ADDENDUM #2

Reference: UVSC Science Building Remodel Phase II, 06005790

addendum 002

project: UVSC Science Room Remodel
 project no.: 05565.00
 date: June 30, 2006
 owner:
 bid date: 07/05/2006
 bid time: 03:00 PM
 no. pages:

PARTIAL SECTION 1/S302 CLARIFICATION

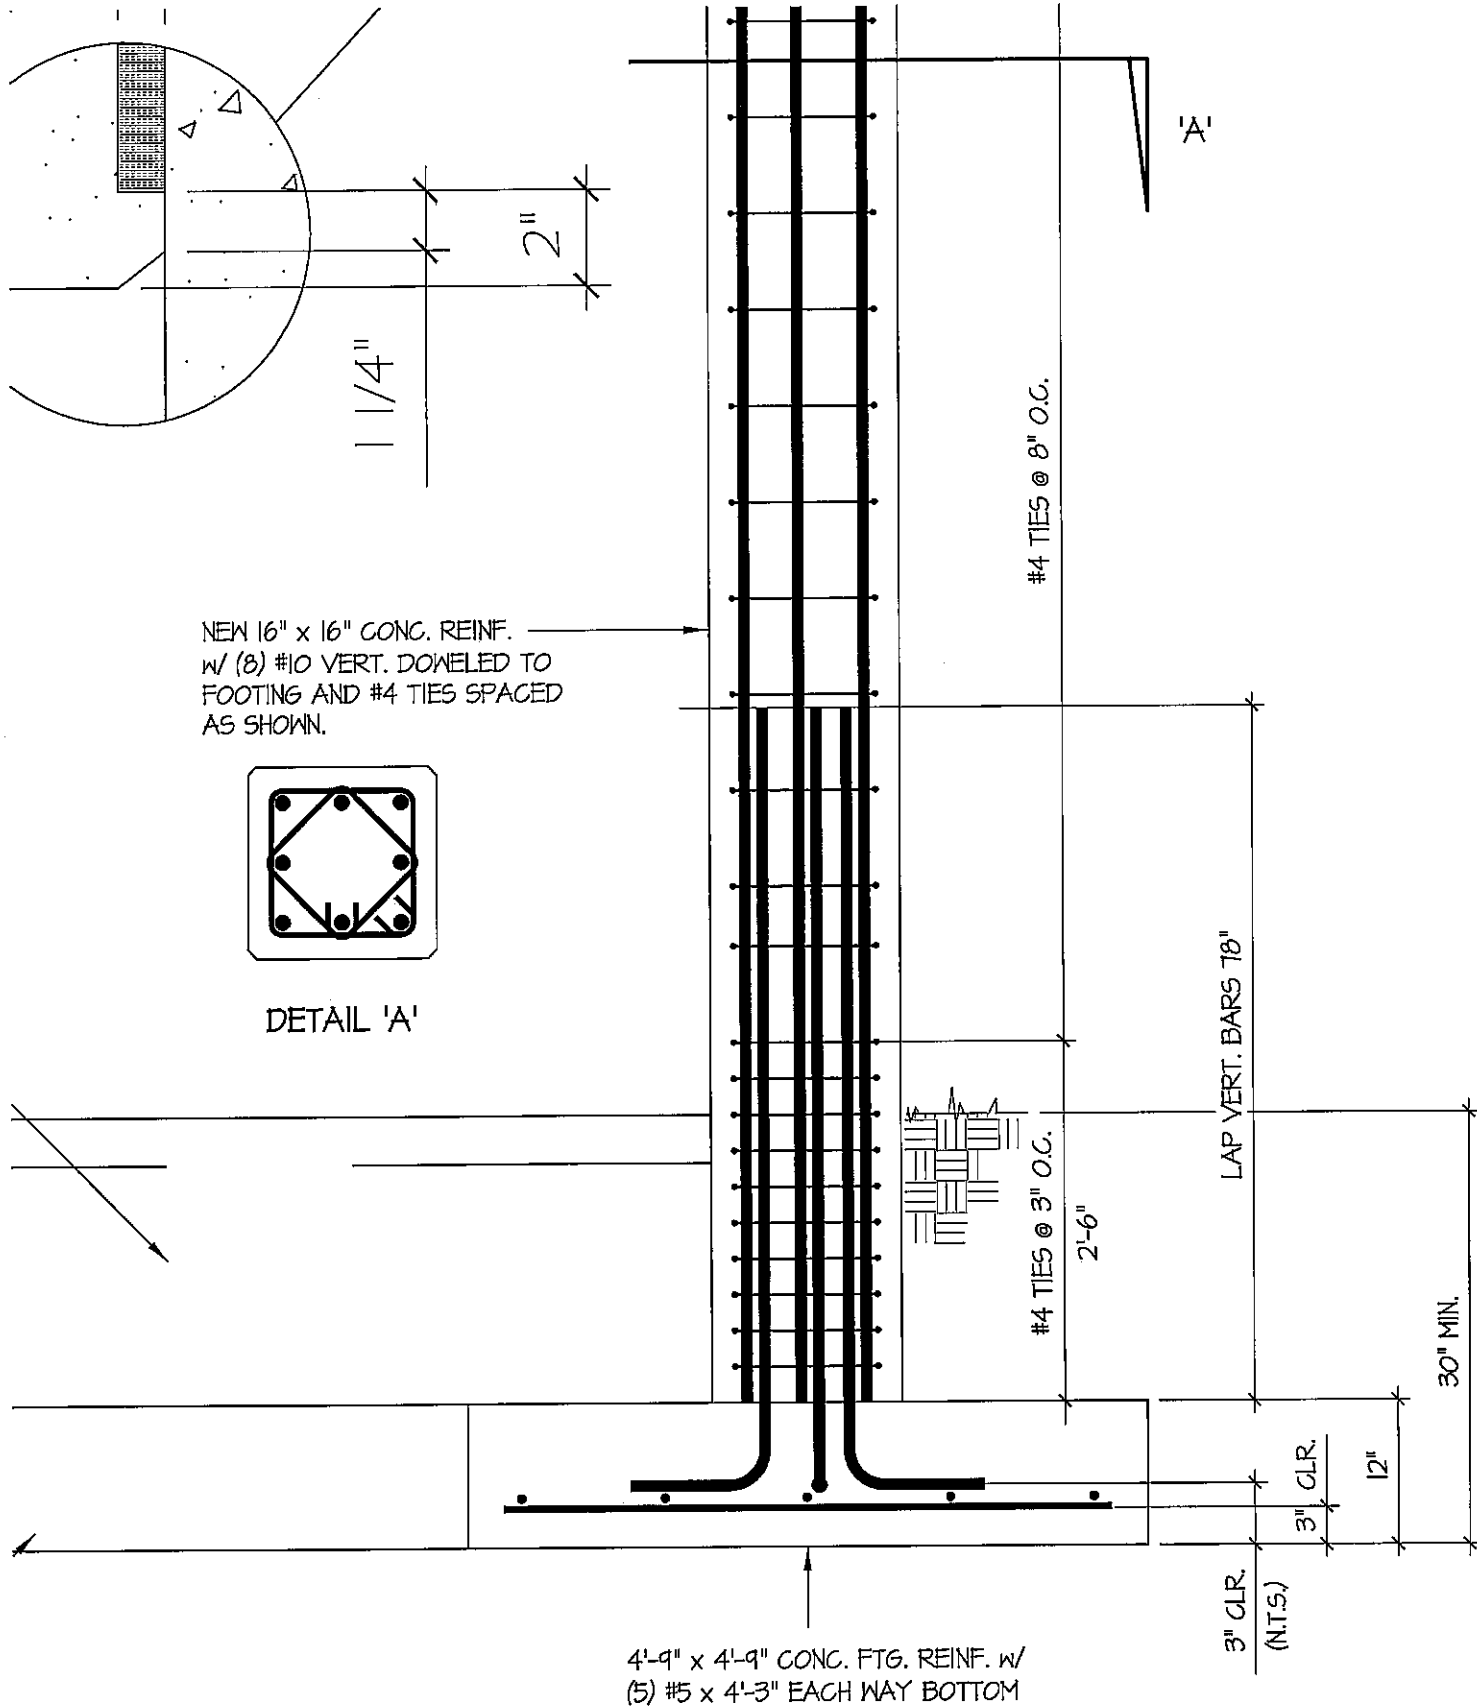
Item	Description
1	Sheet S302 - Revise the note referring to the new 16" x 16" column to read "NEW 16" X 16" CONC. REINF. W/ (8) #4 TIES SPACED AS SHOWN". See attached Detail A.
